SUNDRY NOTICES AND REPORTS ON WELLS Do not use this form for proposals to drill or to re-enter an abandoned well. Use form 3160-3 (APD) for such proposals RECEIVED					6. If Indian, Allottee or Tribe Name		
							SUBMIT IN TRIPLICATE - Other instructions on reverse side.
Type of Well					8. Well Name and No. TODD 26K FED 10		
Name of Operator DEVON ENERGY PRODUCT	EAL COM		9. API Well No. 30-015-27102-00-S1				
3a. Address 333 WEST SHERIDAN AVE OKLAHOMA CITY, OK 73102		3b. Phone No. (include area code) Ph: 405-228-8429		10. Field and Pool, or Exploratory INGLE WELLS

Devon respectfully requests a 2 year TA status for the captioned well.

Todd 26K Fed 10

Attached: Current and Proposed Wellbore Schematics.

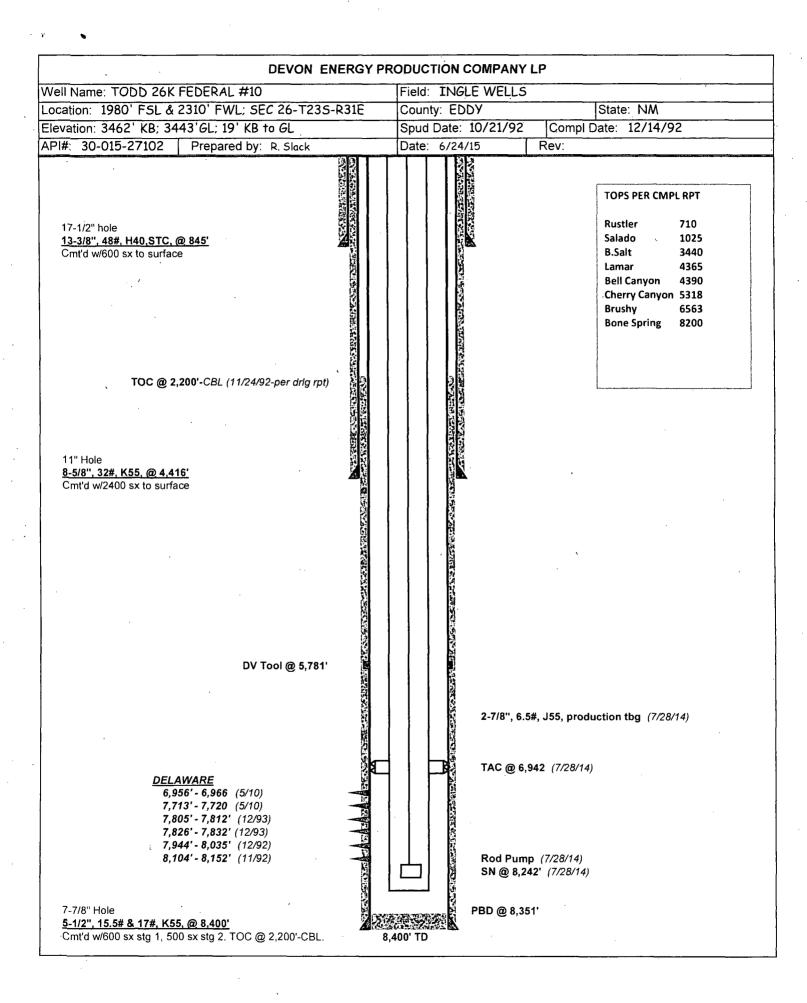
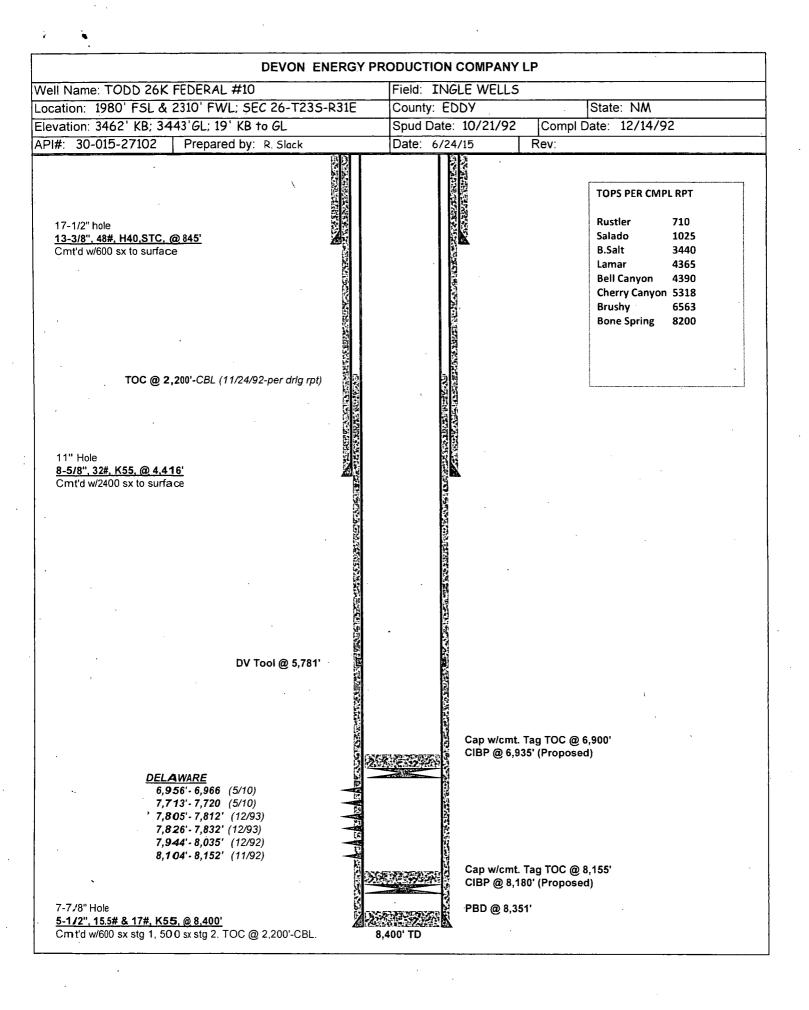
1. Operator shall set a CIBP at 6,906' (50' above top most perf) and <u>place 170' Class C</u> cement on top.

TA status approved for a period of 12 months ending 01/28/2017 subject to conditions of approval.
